**TECHNICAL MEMORANDUM**

**SUBJECT:** Woodland Research and Technical Park – Storm Drainage Review

**EXHIBIT 1**

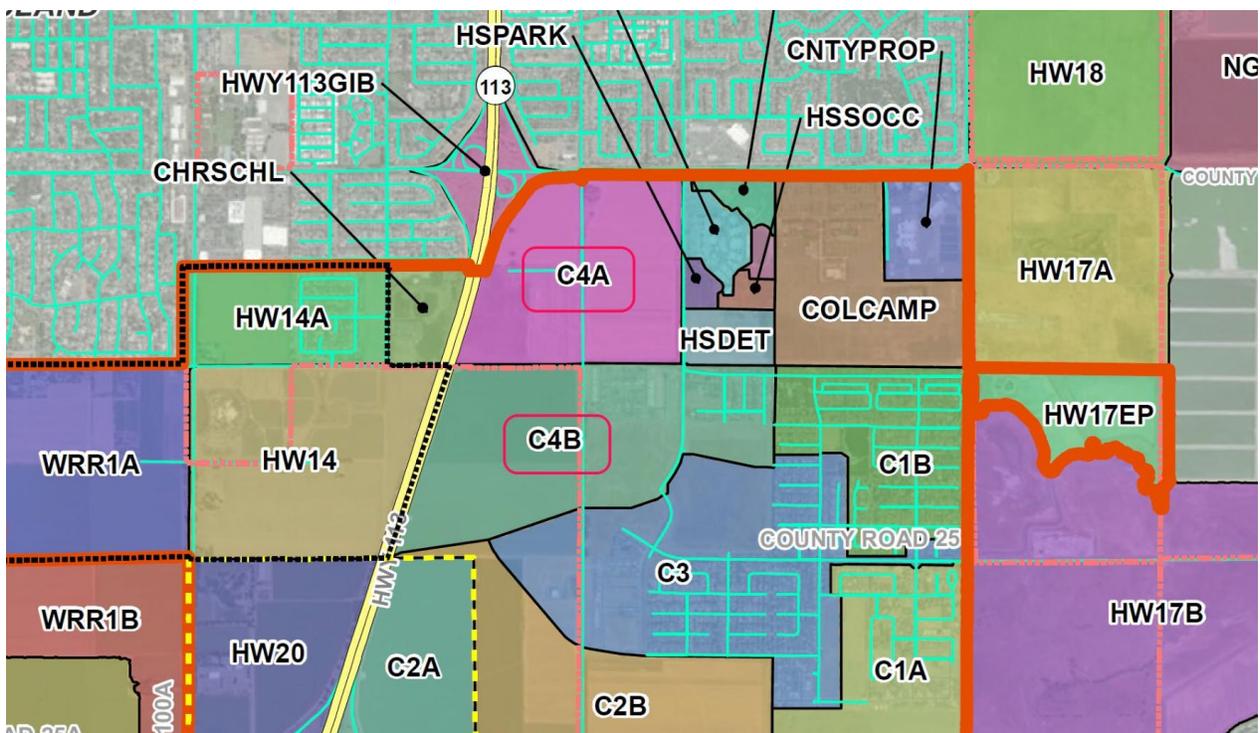
Because the storm drain located upstream of Pioneer Avenue was not constructed in 2014, the definition of the sub-watersheds and tributary pipelines in DA2 were based on planning estimates available at the time of modeling. The DA2 effort defined the watersheds north and south of the Farmers Central Road alignment in more of a lumped fashion, with the C4A and C4B watersheds shown in the excerpt below from the Storm Drainage Facilities Master Plan (SDFMP) document under DA2 (see **Exhibit 1**, below). Both the C4A and C4B watersheds are modeled as draining into the Farmers Central drainage corridor at Pioneer Avenue under DA2.

The DA2 was never updated to reflect as-constructed conditions, nor was the DA2 effort necessarily intended to provide detailed hydraulic grade line (HGL) information for all tributary pipelines. The Farmers Central drainage corridor was modeled to size regional detention basins and confirm the channel/trunk capacities needed to drain detention basins.
